City of Lone Tree Planning Commission Agenda Tuesday, October 14, 2014

SUBJECT: RidgeGate Section 15, Filing 21, Lot 1 (Morningstar at RidgeGate)
Site Improvement Plan, Project File #SP14-30R

**MORNINGSTAR AT RIDGEGATE
SITE IMPROVEMENT PLAN
COVER SHEET**

MORNINGSTAR AT RIDGEGATE
SITE IMPROVEMENT PLAN
SITE PLAN

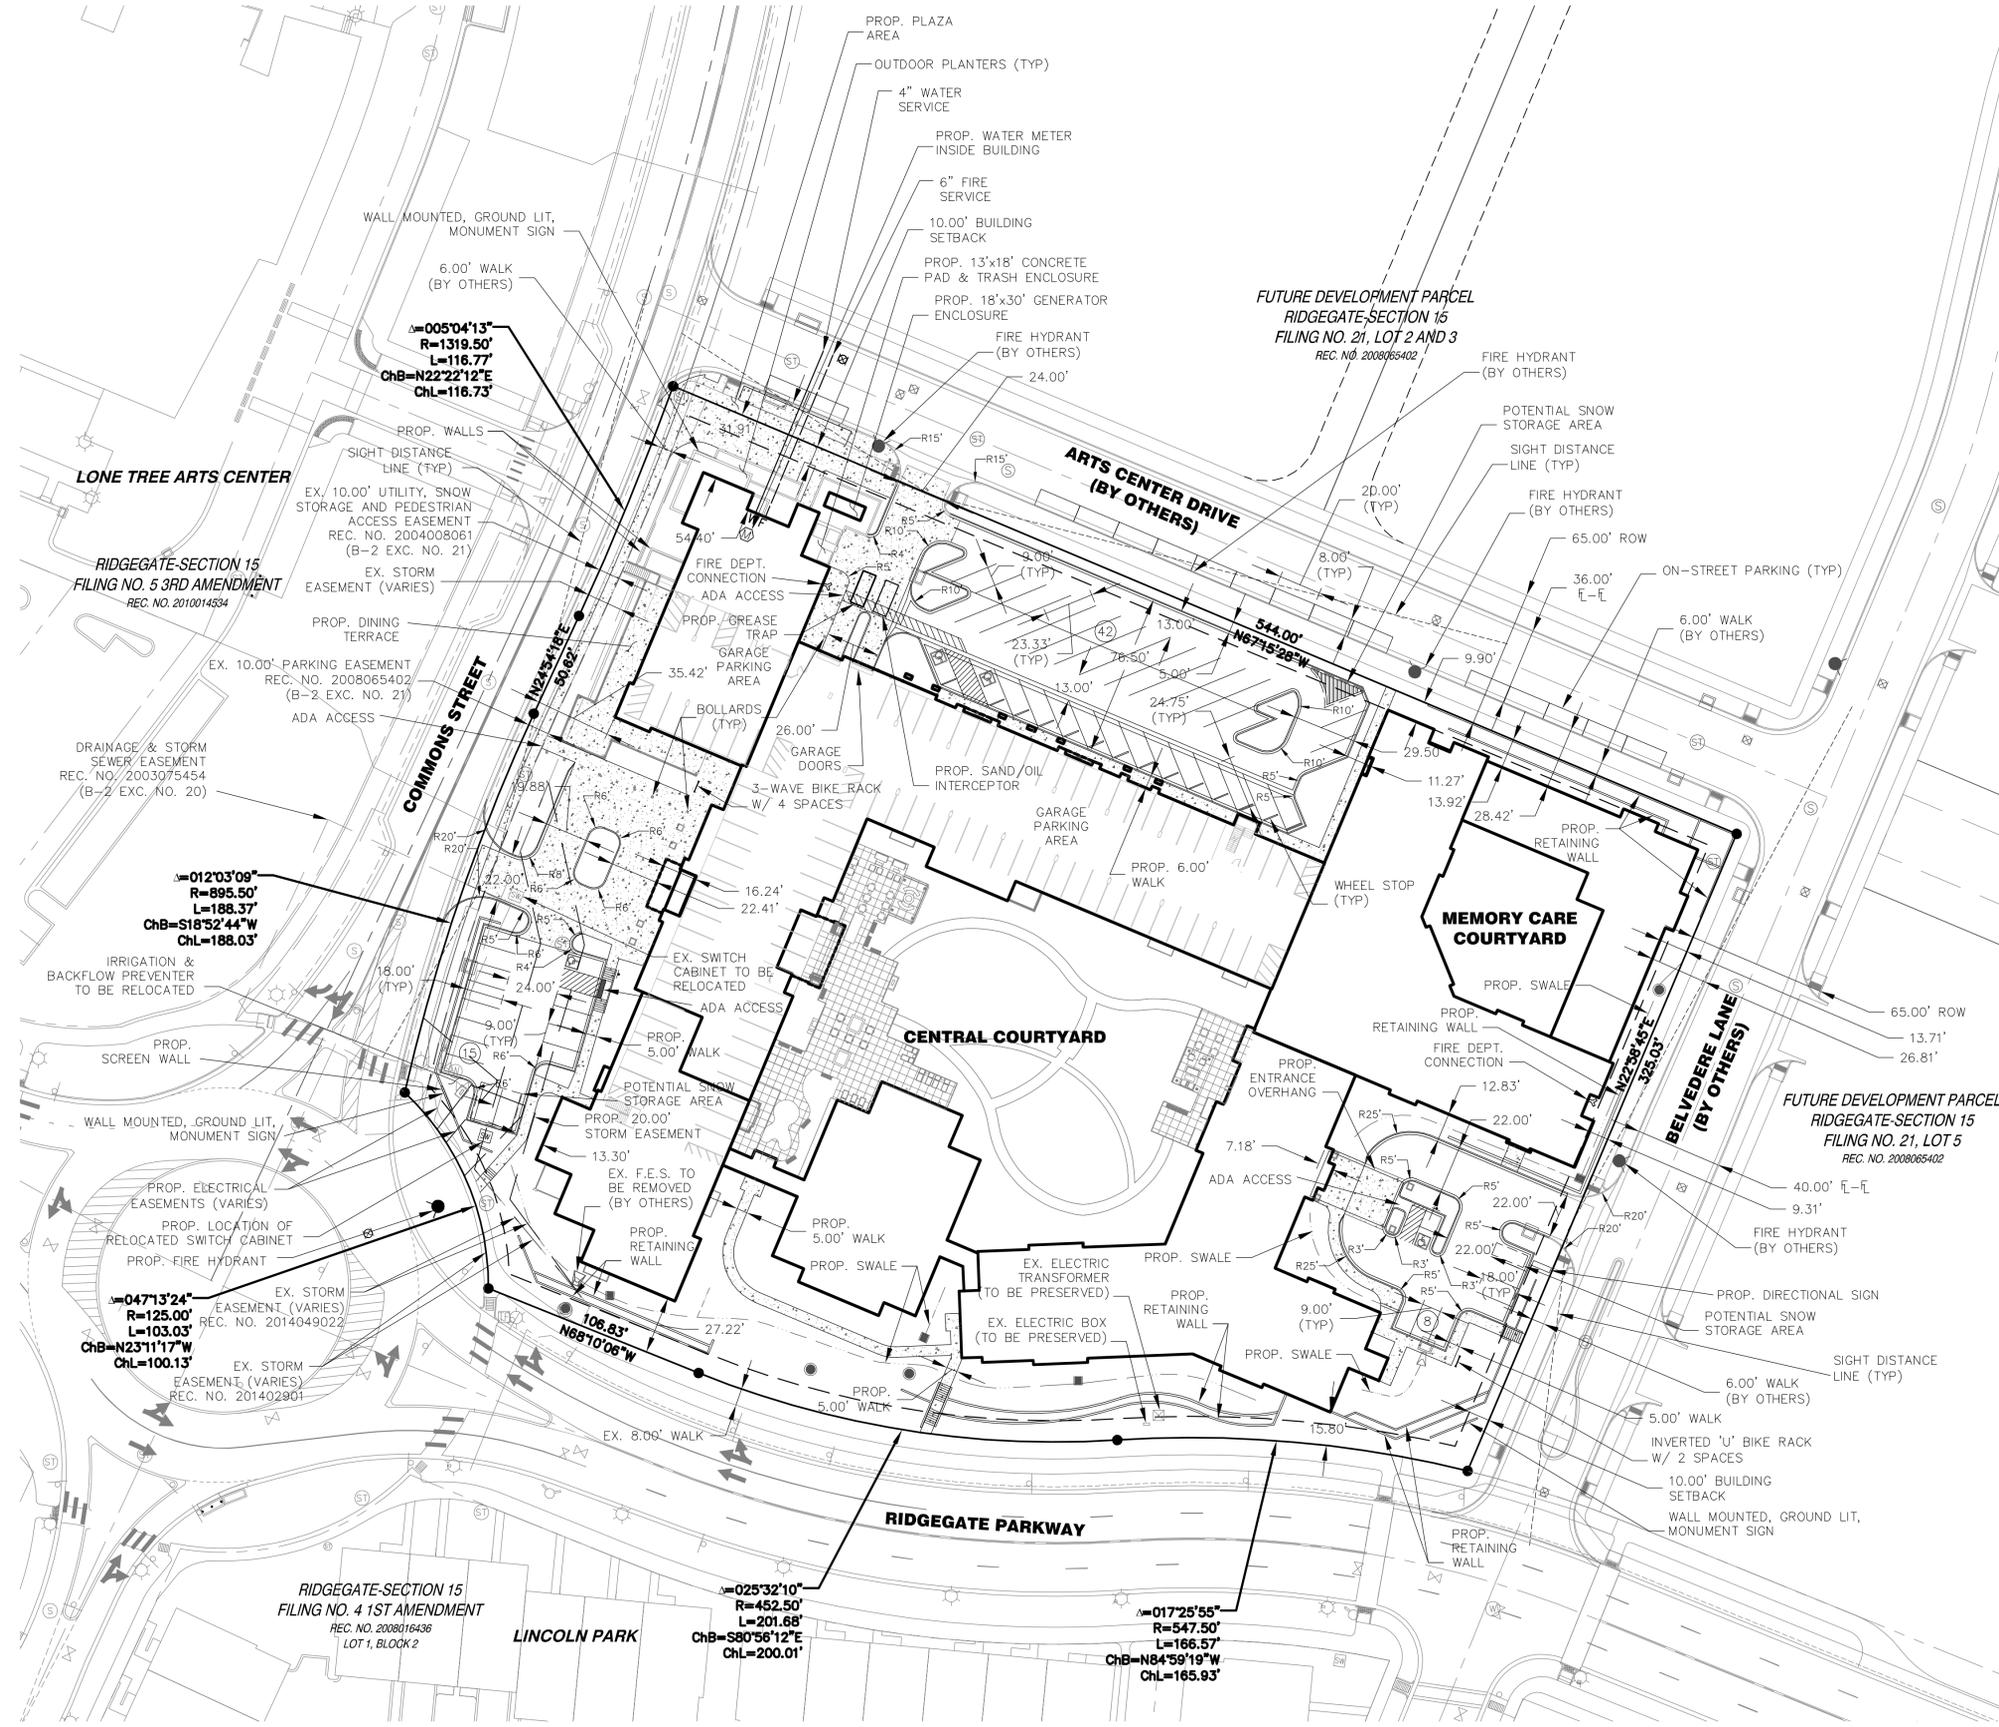
3. There are existing storm sewer easements along the east side of Commons Street and across the SW corner of the proposed Morningstar site (recorded with the Filing #21 Plat, at # 201402901, and subsequently based on final constructed location of the incorporated storm sewer, at # 2014049022). Both of these storm sewer easements should be shown on Sheets 2 through 6 of this Site Plan Package. In addition, the location of the existing storm sewer (shown on Sheet 3) is incorrect, and the correct "as constructed" location should be shown. Conflicts between the storm sewer easement(s), and the proposed site development and landscaping plans, should be clearly demonstrated. The conflicts will need to be addressed appropriately

- b. The proposed location of the relocated switch cabinet must be outside of the storm easement.
 - c. No trees (re: Sheet 5) or other large landscaping plantings would be allowed within the storm sewer easement.

- a. Provision of both domestic and fire protection connection(s) will be required (see Sheet 3, Grading and Utility Plan). The Site Plan (Sheet 2) should be updated to match Sheet 3 information regarding the water service(s).

5. A proposed Directional Sign is indicated at the south side of the driveway connection off Belvedere Lane. The sign should be located back from the street sufficiently that it does not adversely impact the sight distance triangle to the south for traffic exiting the site at this location. As shown on Sheet 2, the location appears to be clear of the sight triangle. As located on Sheet 11, the sign may be slightly in conflict.

Project Number:	Drawn By:	Checked By:	Sheet Number:
092004	JDM	GKP	3

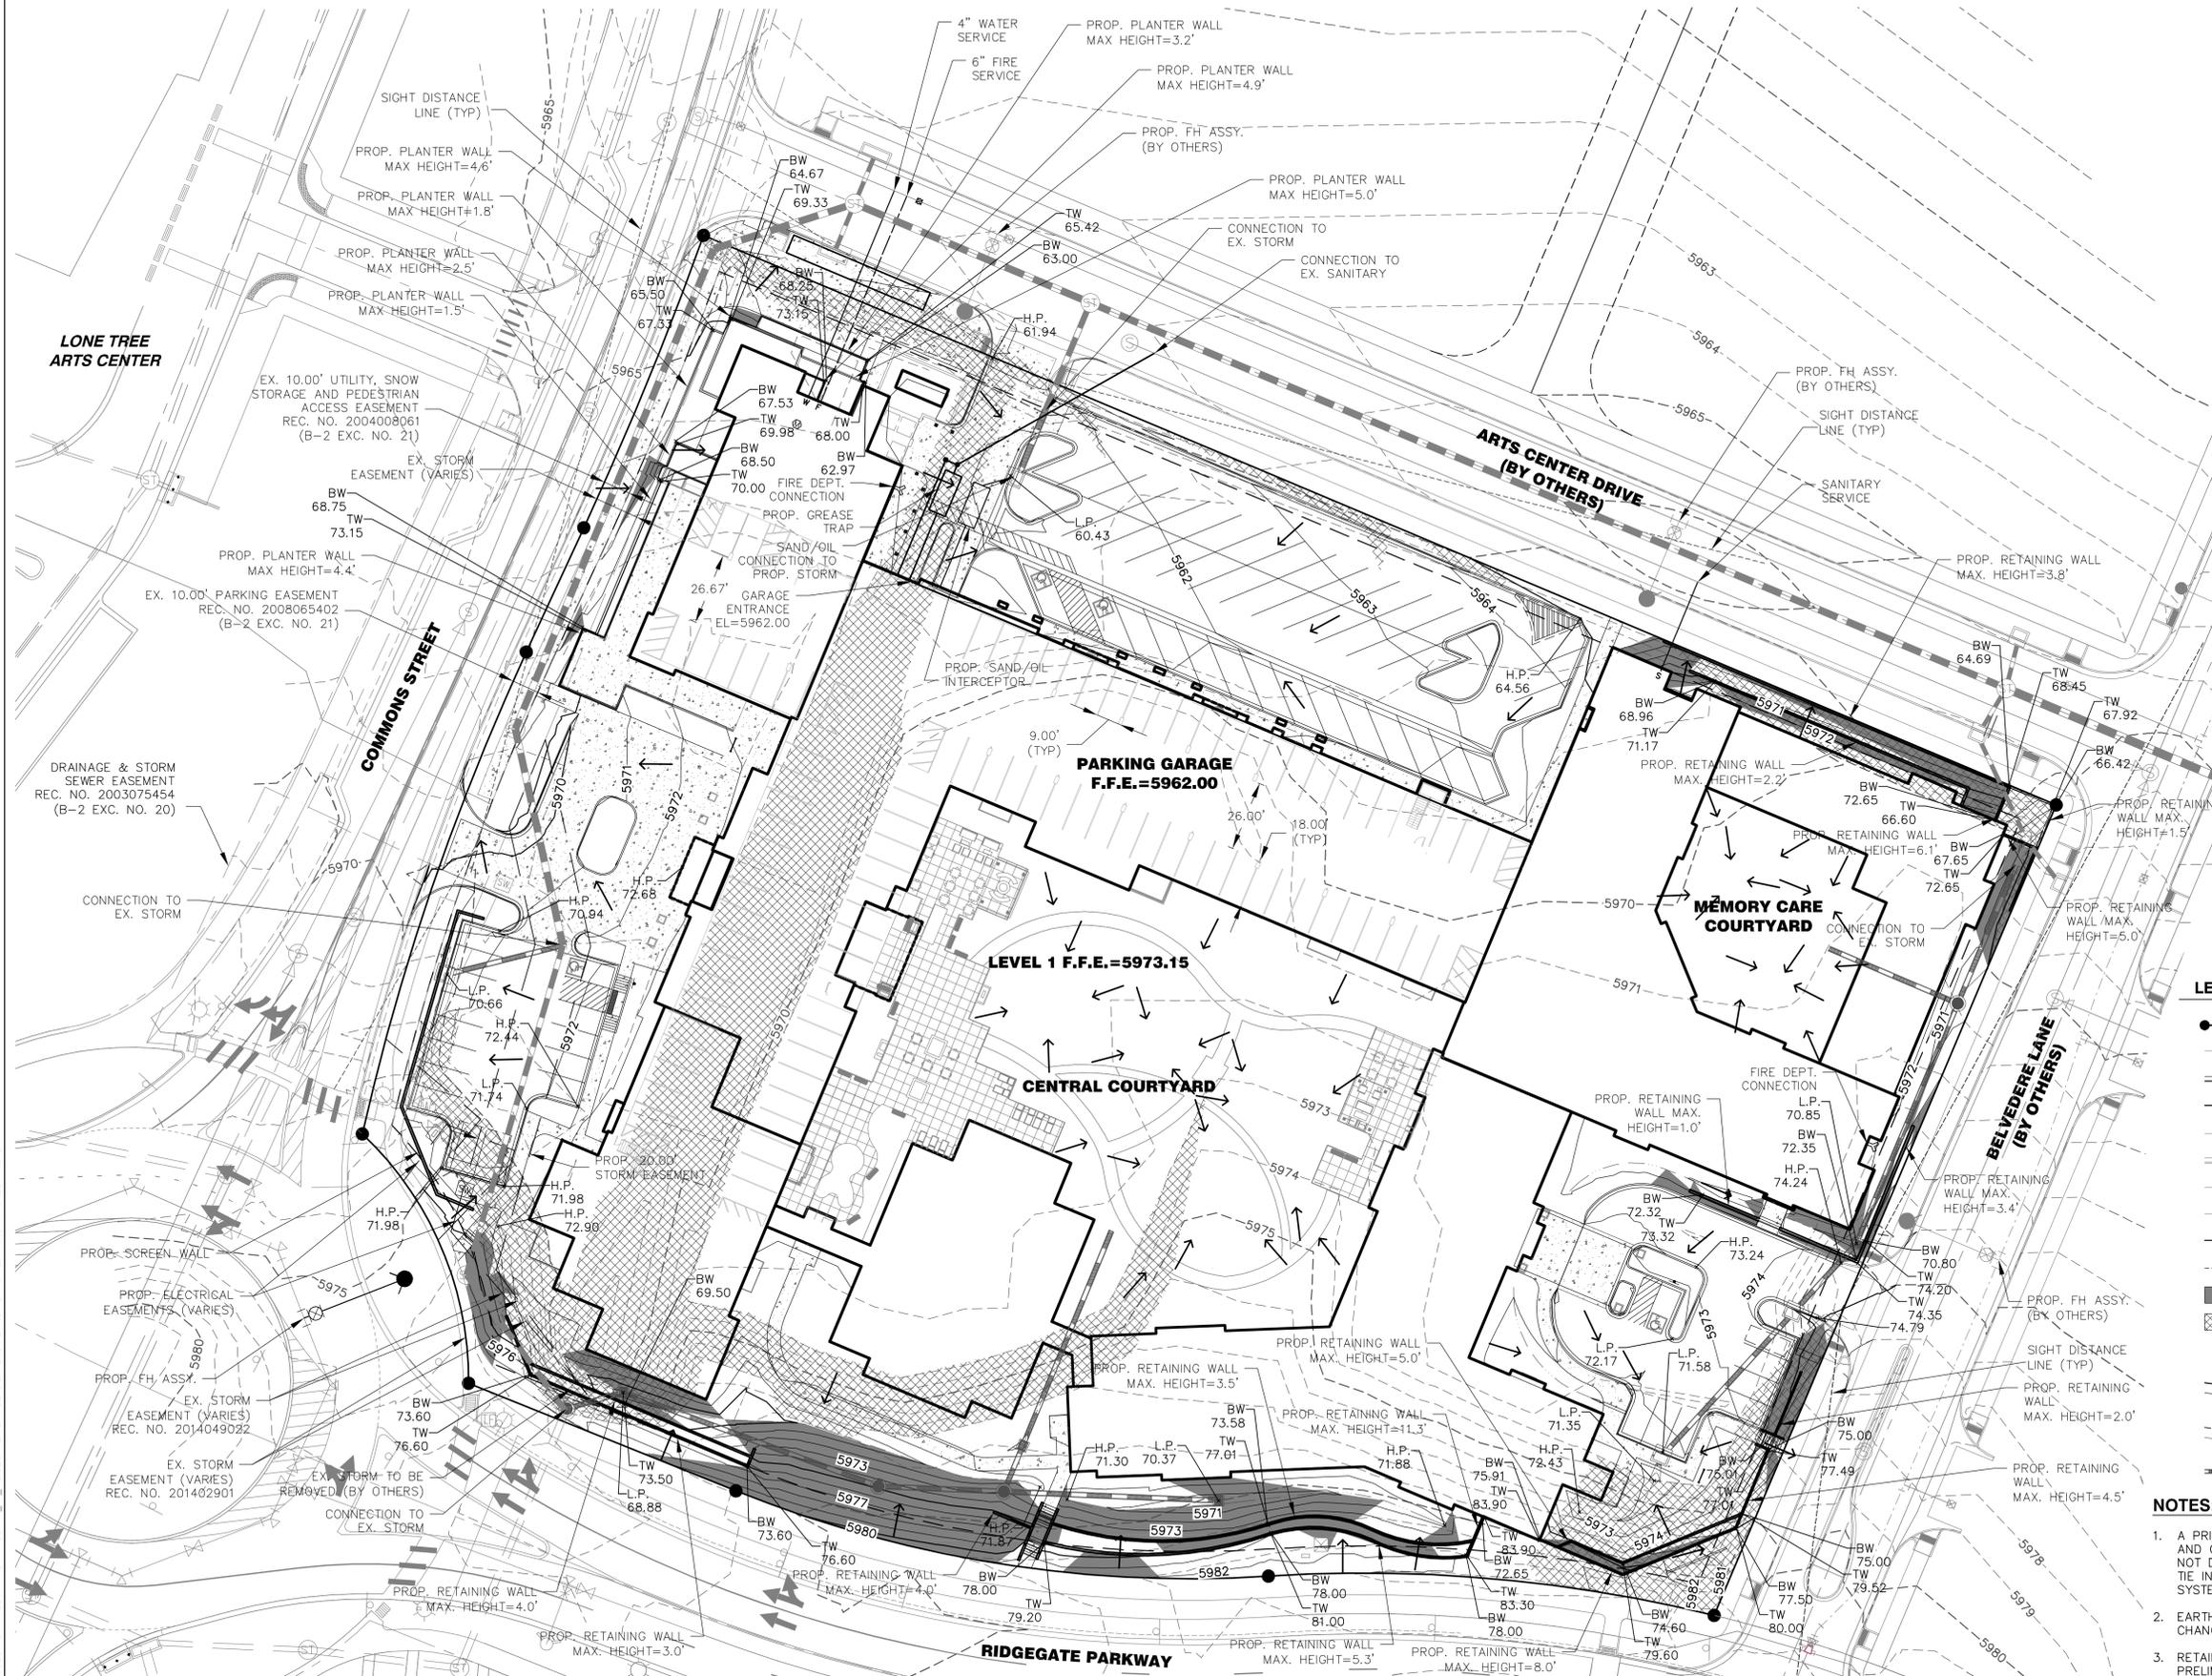
Sheet 3 – Grading & Utility Plan:
